Technical Service Bulletin

Subject: CHECK ENGINE LIGHT ON WITH DTCs P24C6:00, P24AE:00, P24B1:00 AND/OR P24AF:00	Bulletin No.: 01-003/20
	Last Issued: 02/13/2020

2018-2019 CX-5 SKYACTIV-D 2.2

PROPER ORIENTATION OF PARTICULATE MATTER (PM) SENSOR:

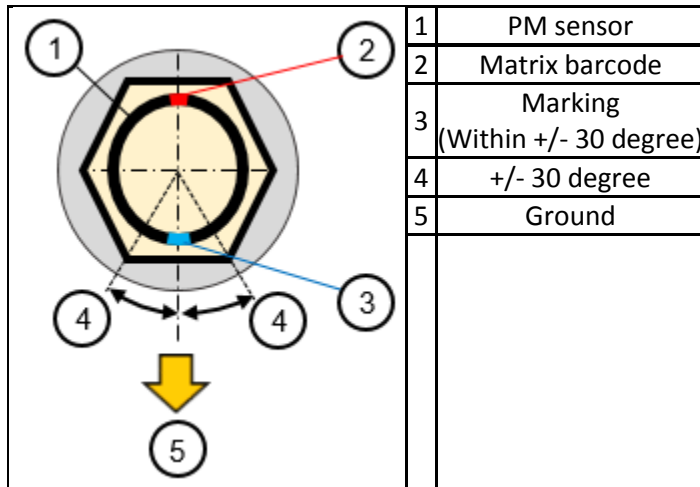
NOTE: To reduce water accumulation in the PM sensor, follow the steps below when installing the sensor so the sensor element faces upward.

1. Find the matrix barcode (2) on the PM sensor (1) that faces the same direction as the sensor element (See "Location of matrix barcode" below).
2. Mark (3) the sensor body 180 degrees opposite of the matrix barcode and harness side of the free nut.
3. Install the PM sensor so that the marking faces downward to the ground (5) $\pm$ 30 degrees (4).

NOTE: When tightening the free nut, the sensor housing may turn together. For the best result, temporarily tighten the nut holding the sensor housing at 15 degrees before the target angle, then tighten to the specified torque.

- **Tightening torque: 30-44 ft-lbf {40-60 N·m, 4.1-6.1 kgf·m}**

Location of the matrix barcode:

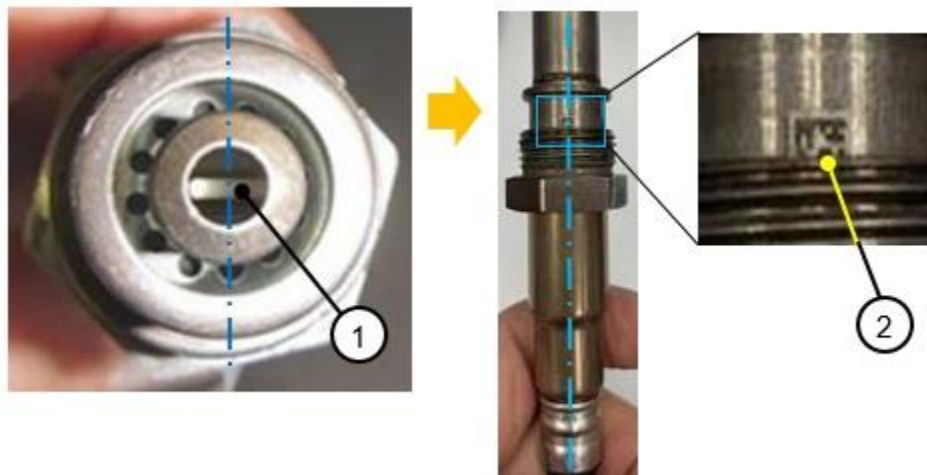
Locate the sensor element plate (1) and imagine the dashed line as shown below. The matrix barcode (2) is printed at the crossing of the line and either side of the sensor housing.

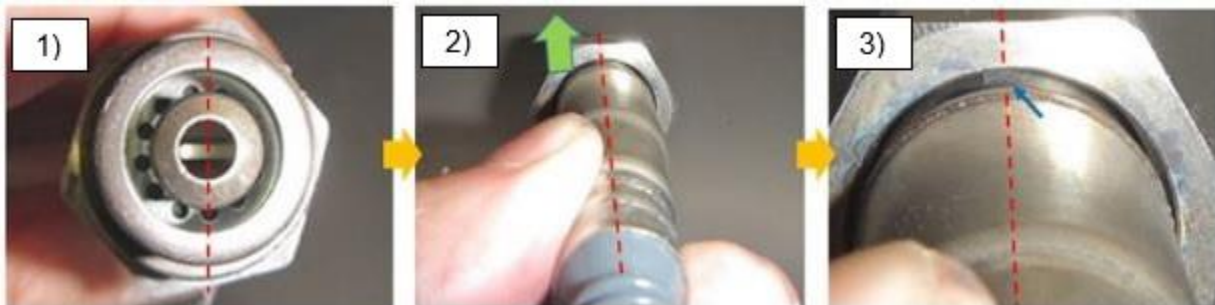
NOTE: If the matrix barcode is not found, it may be hidden under the free nut. This may be due to a variation in manufacturing.

Use the following procedures to locate it the matrix barcode.

Procedure (A) Looking from the sensor element side:

- 1) Locate the sensor element plate.
- 2) Push the free nut downward.
- 3) Hold the nut to create clearance, then inspect the area shown below by the arrow.

**Procedure (B)** Looking from the harness side:

- 1) Locate the sensor element plate.
- 2) Push the free nut upward.
- 3) Hold the nut to create clearance, then inspect the area shown below by the arrow.
